16/02-04A 20130 Wasche Road Master Plan #16/02 Edw Chiswell

# Edward Chiswell Farm Staff Recommended Modifications to Retroactive Design

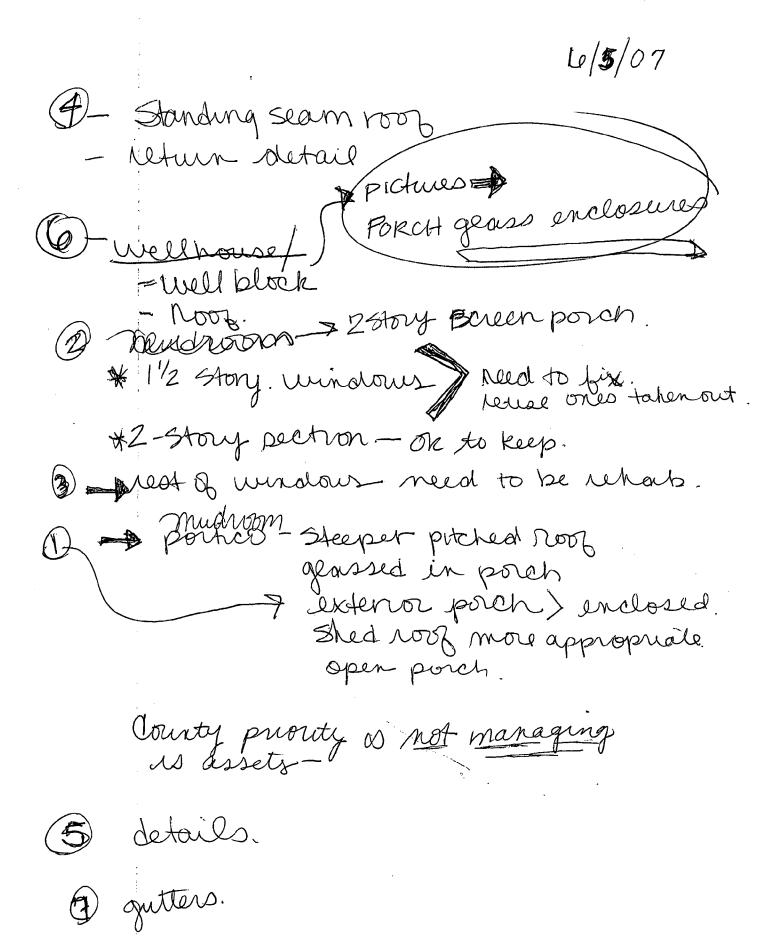
Porch enclosures that are attached to existing decorative porch elements such as this column can cause damage that is both difficult and costly to repair.

This porch enclosure is located behind the porch columns and decorative balustrade, is as translucent as possible, and is reversible. Major framing members are also located behind columns and the balustrade, minimizing their visibility.

PROPOSED MASSING DIAGRAM.

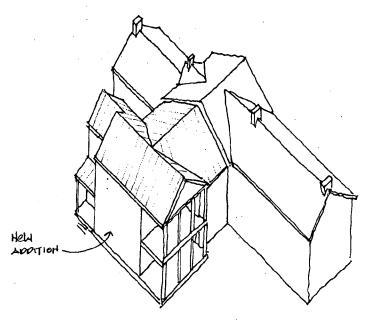
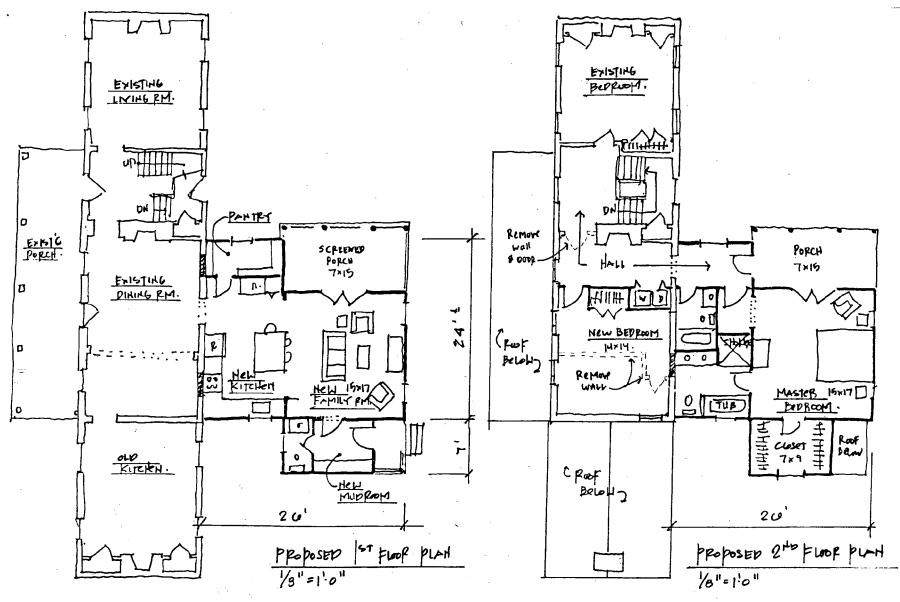
The addition's design will be modified so that the new massing will not visibly encroach on the historic 1-1/2 story section.

# STAFF SUGGESTION #2

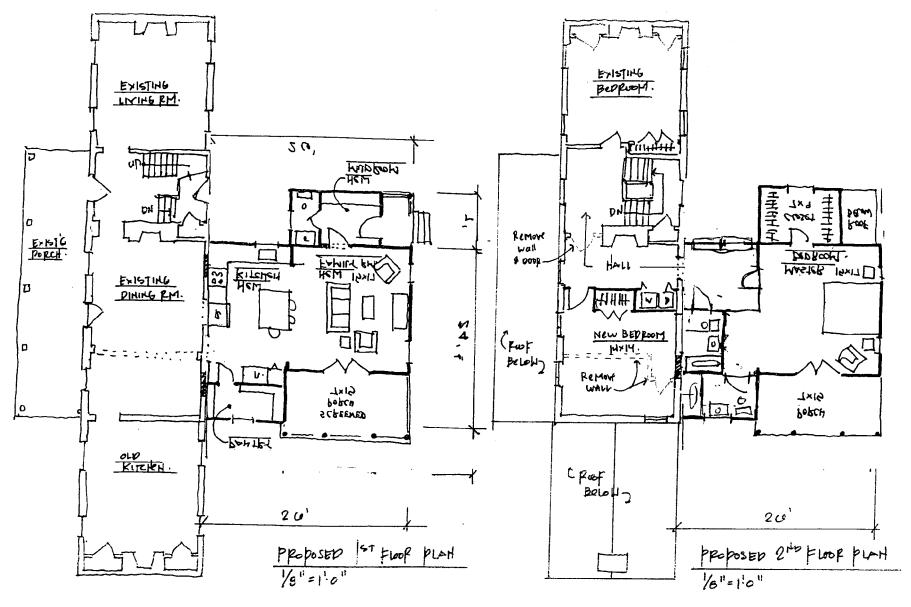
forms were on the back table. Have these work permits been 1 2 duly advertised? 3 MS. FOTHERGILL: They were on April 28, 2004. MS. O'MALLEY: Thank you. Is there anyone here to 4 speak in opposition to case C, 9715 Capitol View Avenue; Case D, 10012 Capitol View Avenue; case F, Frederick Road in 6 7 Clapsburg (indiscernible); case G, Noyes Drive in Silver Spring, case I on Jones Bridge Road in Chevy Chase; case K on 8 Washington Street in Kensington; case L on Riggs Hill Way in 9 10 Brookeville? 11 Madame Chair, here and now I move that MR. FULLER: we approve case 31/07-04B, case 31/07-04C, case 13/10-04A, case 12 13 36/04-04A, case 35/54-04B, case 31/06-04I, and case 23/148-04A14 based on the recommendations of the staff report. 15 MS. WILLIAMS: Second. 16 MS. O'MALLEY: All in favor? It's unanimous. of those were your cases, you're free to go home. You can 17 check with staff, please. Thank you for doing such fine work 18 19 on your applications. 20 Should we go ahead and start with case A? This is 21 the continuation. Do you have the staff reports? 22 Just briefly, I would also like to MS. NARU: Yes. note that we've just been handed the revised drawings. A 23
